The A303 Stonehenge Examiners recommended refusal. Why?

Posted on 21 November, 2020 by Stonehenge Alliance

Overview – Extract from ExA report [1]

Sheet 7 [\[APP-017\]](#) showing proximity to the decommissioned A303 byway. Source: Highways England draft DCO

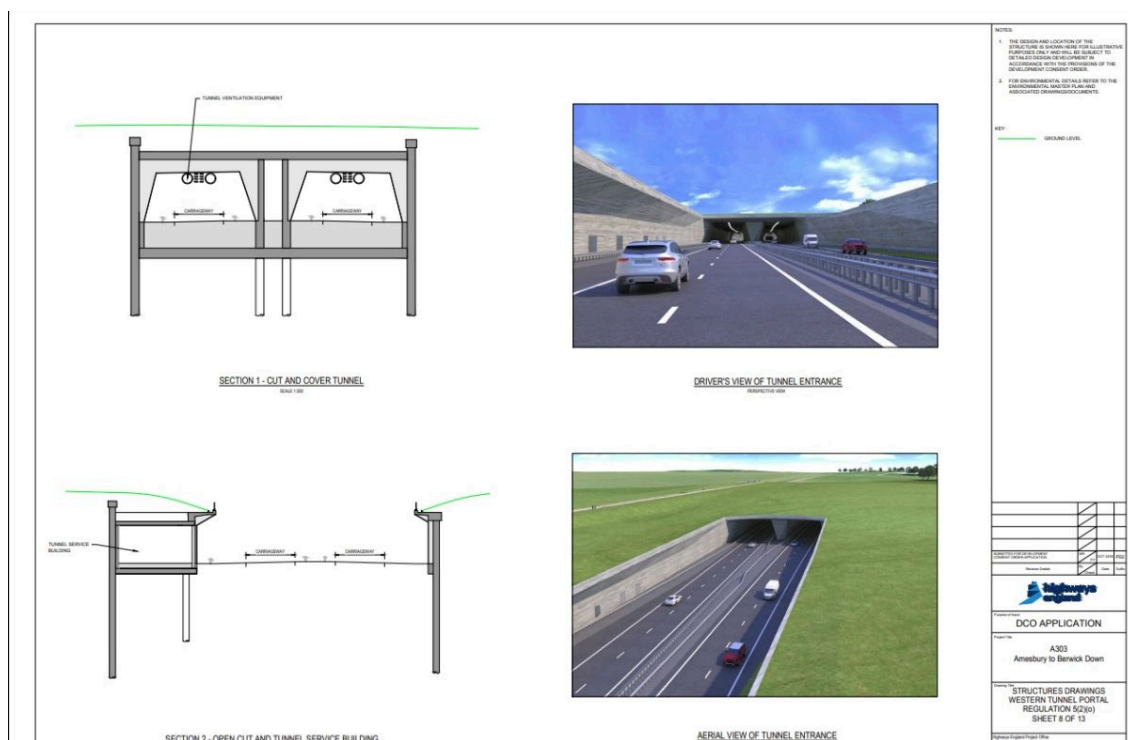
5.7.220. In addition, illustrations shown on the Structures drawings of the portal (Sheets 7 and 8 of [APP-017]), and the Illustrated Examples of Key Design Elements in OEMP Annex A.4 [AS-129], both show aerial views of the western approach and portal, with the decommissioned A303 in pedestrian use as a byway. These give an idea of the scale of the cutting, as a very major engineering element, and also of its proximity to the decommissioned A303 byway.

5.7.221. At the design location of the portal (Chainage 7200), in broad terms the cutting would be 35m wide between retaining walls and 10 to 11m deep, with an overall width of 60m from edge to edge of the sloping grass embankments. At that point, the decommissioned A303 would be only 20m from the permanent fence line along the edge of the embankment, and only 35m from the cutting's retaining wall. These dimensions were set out in SWQ LV.2.3 [PD-014], to which the Applicant responded at [REP6-030].

5.7.222. Moreover, as can be seen from the aerial views, sections of the existing A303 running alongside the footprint of the proposed cutting are embanked above the natural ground level. This would give the cutting greater visibility to users of the byway, with the likelihood of views directly into the cutting and into the entrance to the tunnel.
